Subject: 2723 Brandon Road (CU-02-25) - Work Session review of a conditional use and variance for a proposed replacement Columbia Gas of Ohio utility station.

RE: Conditional Use 02-25; Columbia Gas Utility Station at 2723 Brandon Rd

RE: Major Site Plan 01-25; National Church Residences, 2233-2335 North Bank Drive

Date:6/11/2025

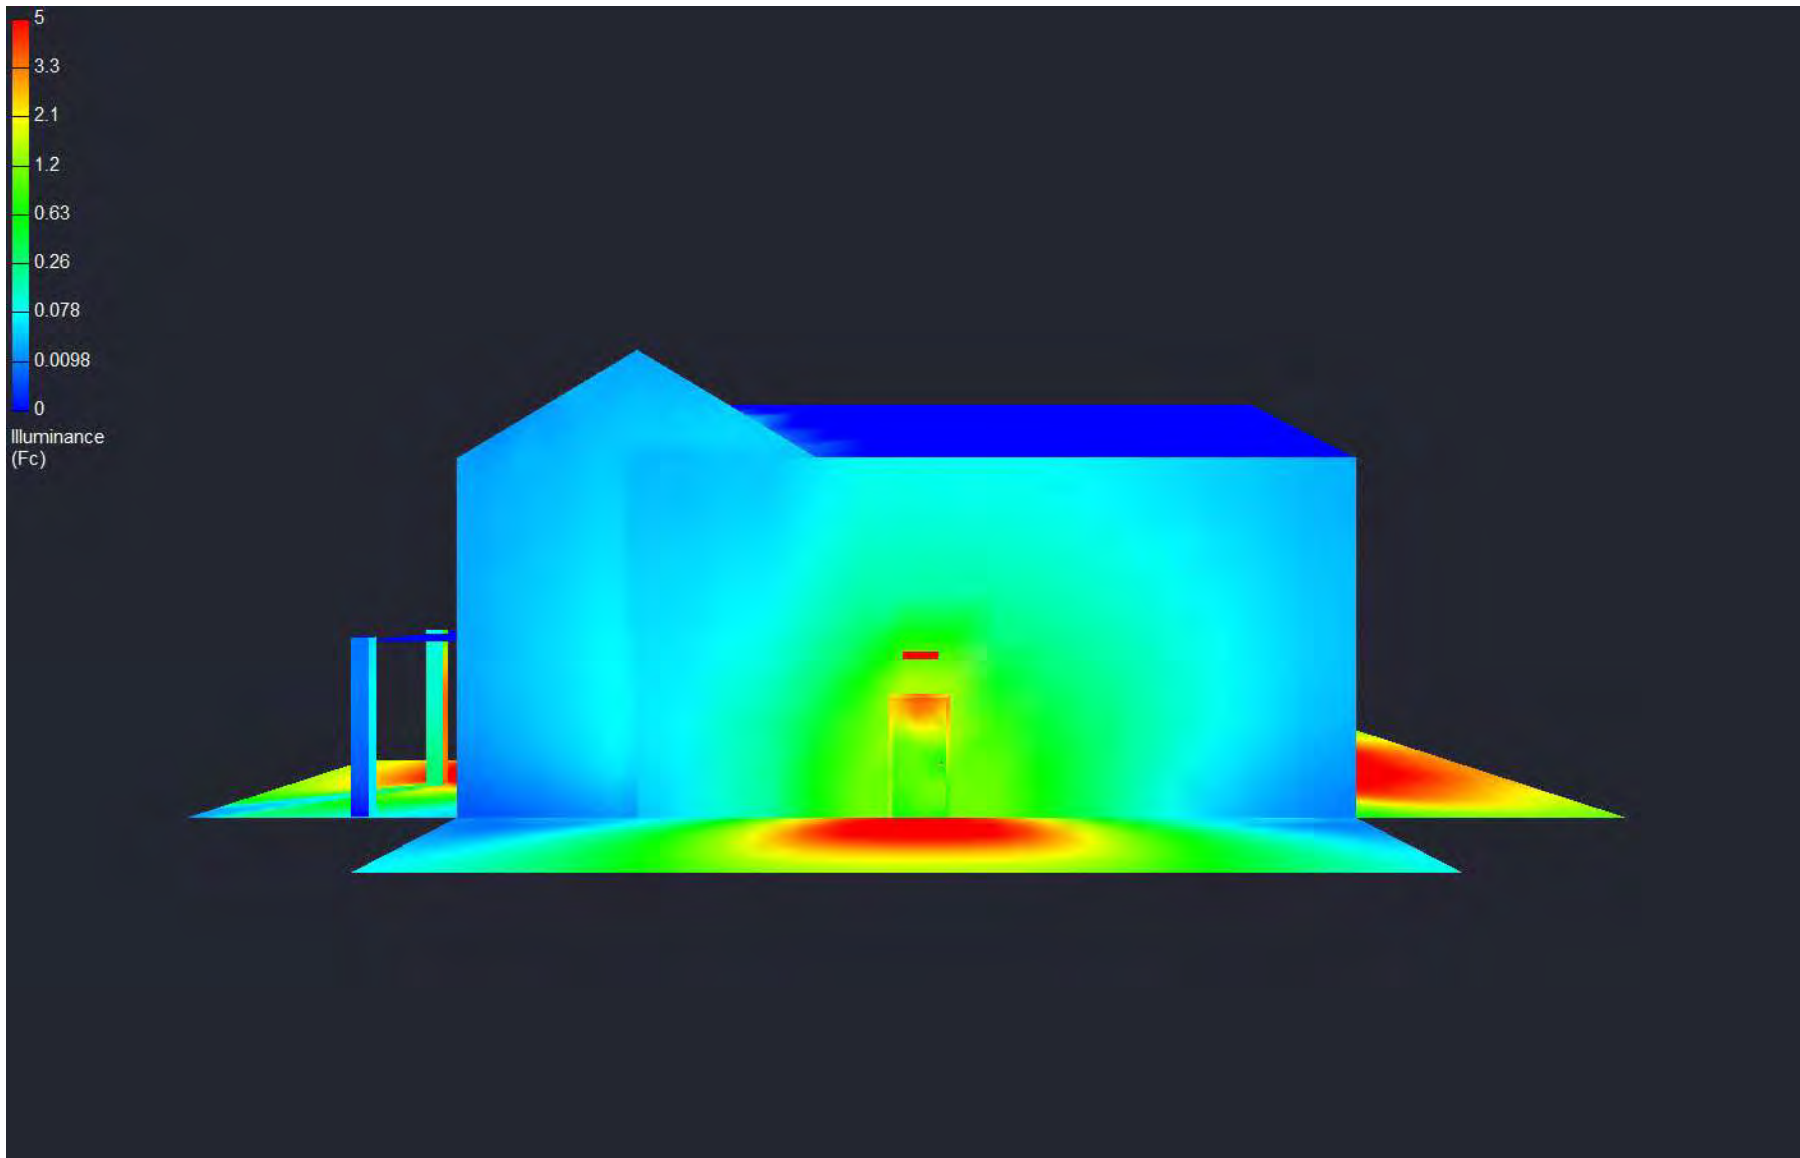
- 6) **Exterior Lighting** – To ensure compliance with the City's Dark Sky® standards, please show the footcandle values extending 15 feet beyond all property lines on the photometric plan. Please continue to look at reducing the hot spot at the front porch for the primary building. Please provide shielding (if possible) on all proposed light fixtures to direct the light down and avoid light spilling onto adjacent residential properties- recessed lighting is also an option.

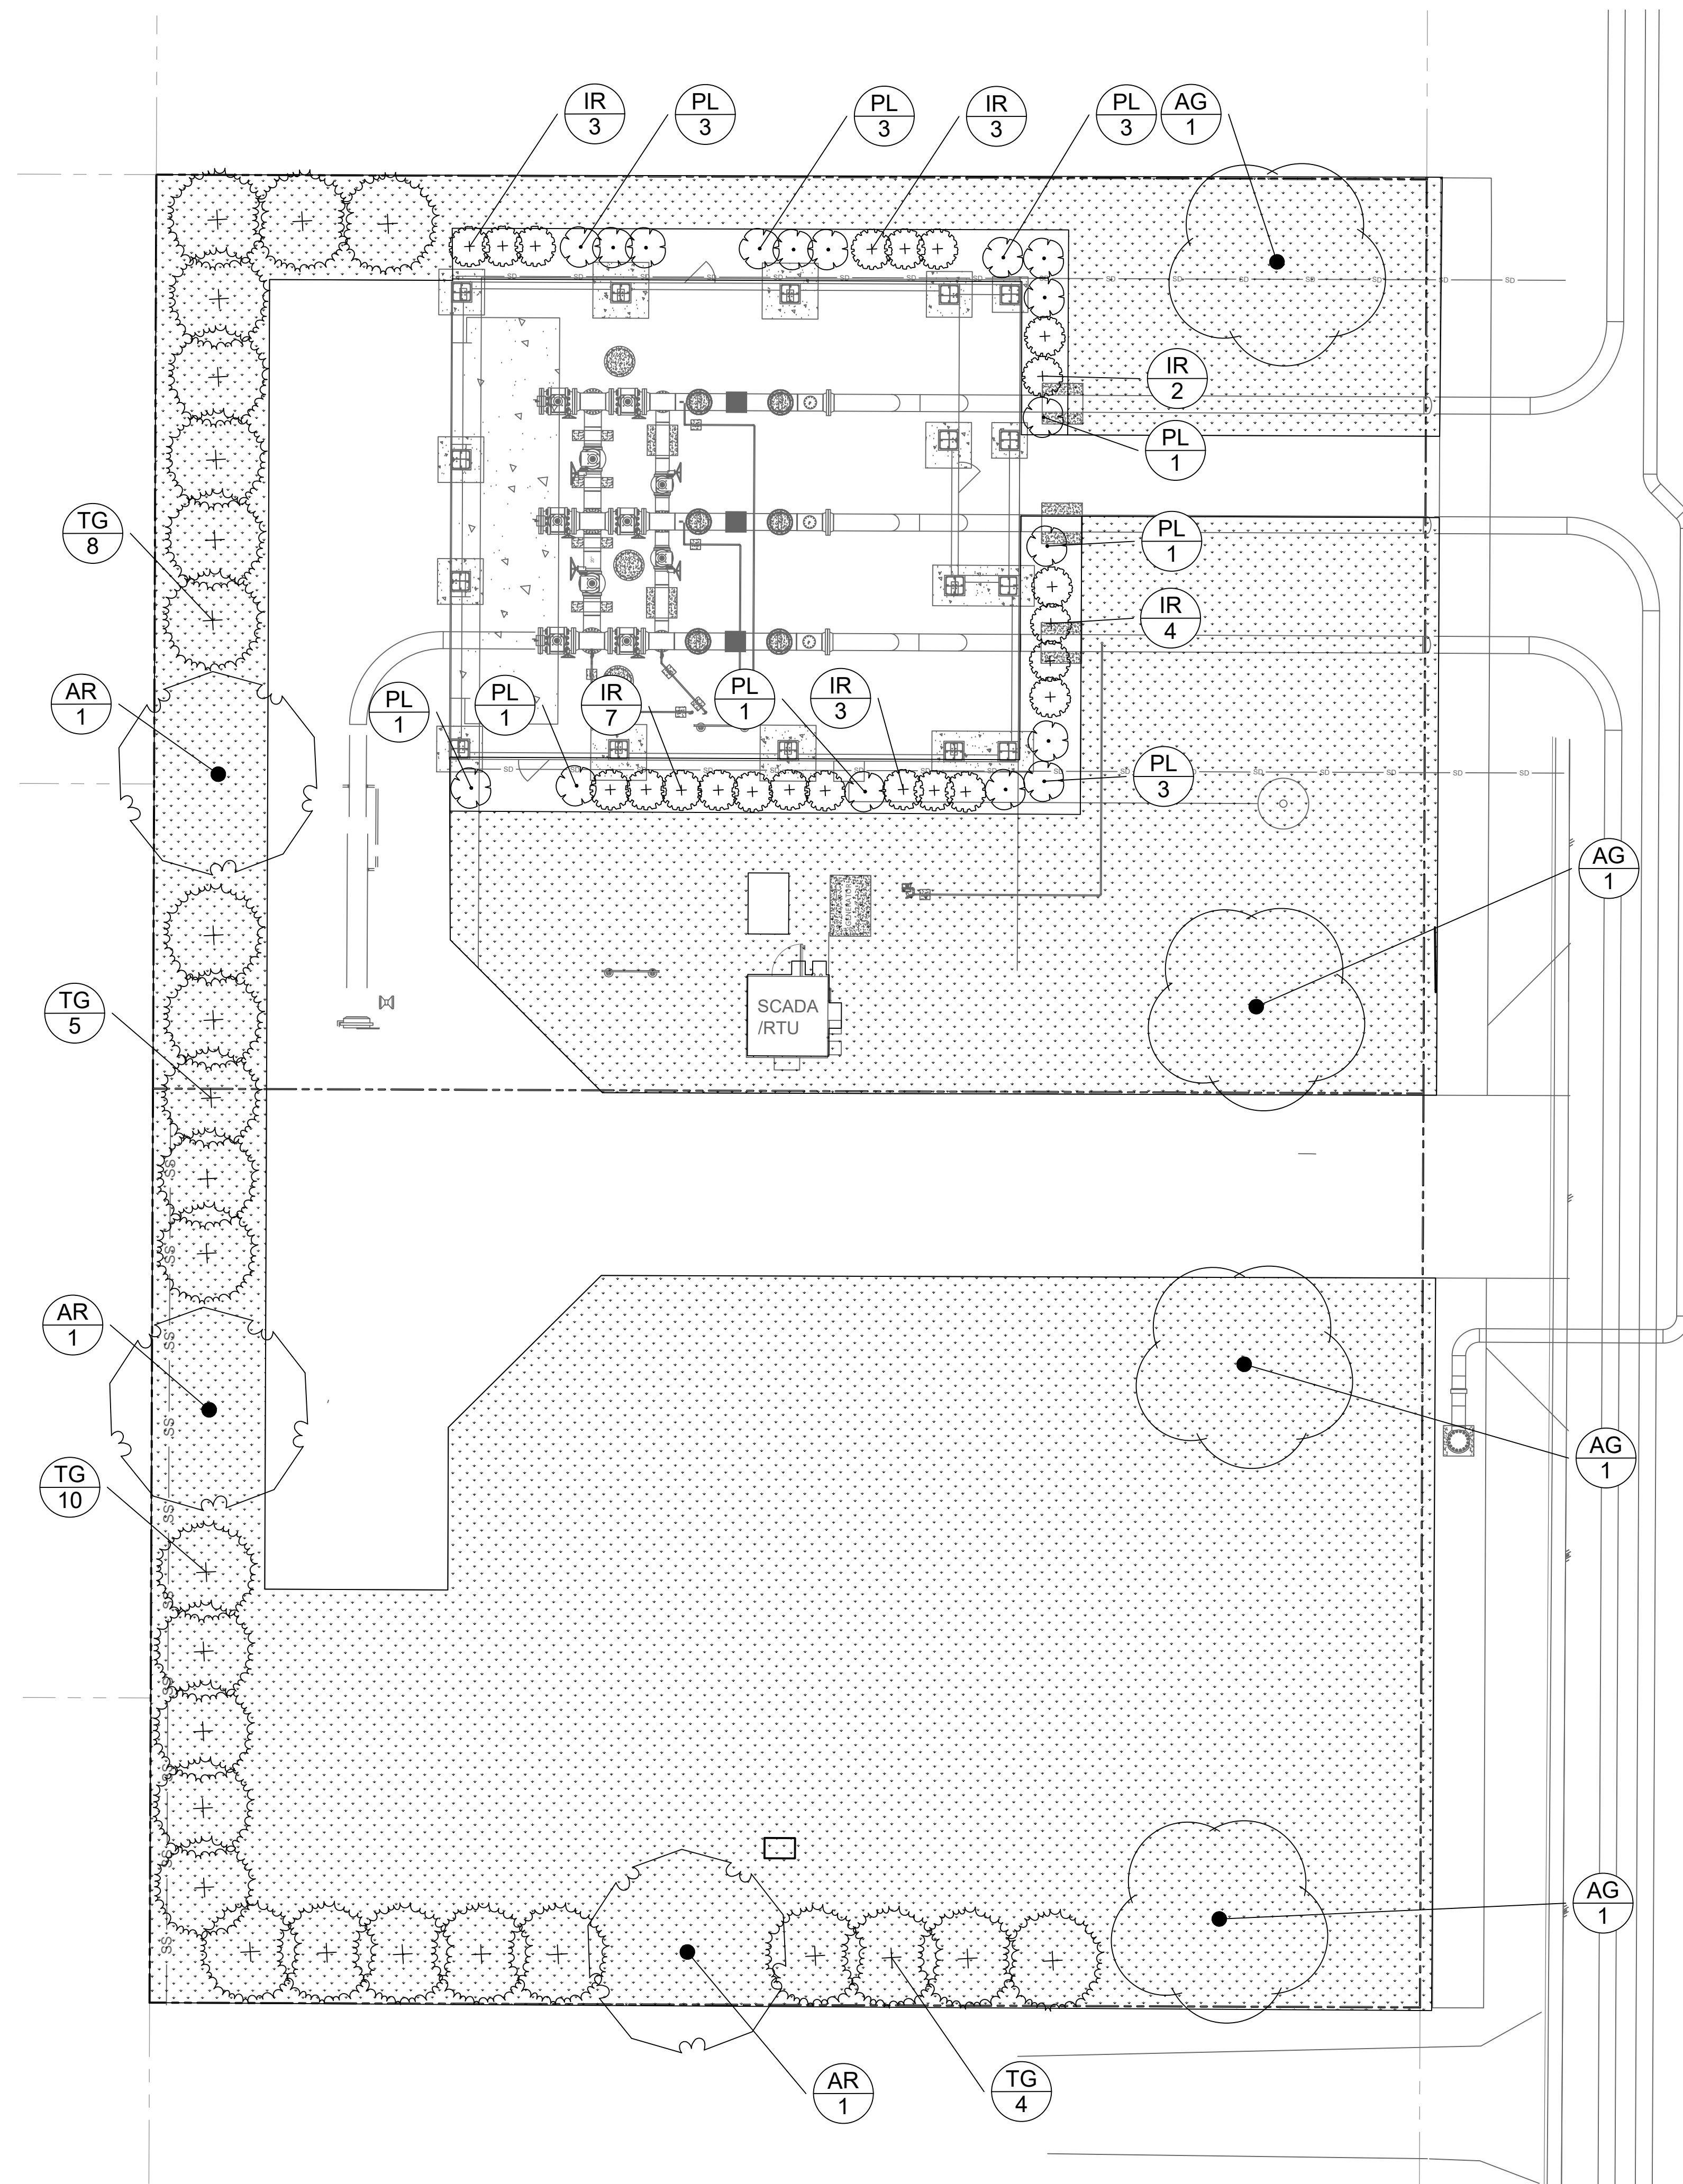
- 4) **Landscape Plan and Fencing** – The proposed landscape plan is under review, and revisions are likely needed. Similar to Ridgeview Station, the use of native trees and plants, along with seasonal color, is strongly recommended. Please show the existing and proposed fencing, which Columbia Gas has acknowledged they will provide and coordinate with the adjacent neighbors to give them the option of keeping their privacy fence or having it replaced with a wood-colored vinyl/composite privacy fence- similar to what was approved for the Ridgeview Station. Requirements include six-foot tall privacy fencing (or a wall) along the side and rear property lines (not in the front yard), and a mixture of deciduous and evergreen trees. A minimum of one tree for each 25 feet of property line length is required on-site (a total of 24). Any mature trees in good condition should be preserved. Proposed plantings above or near utility lines will need caution.
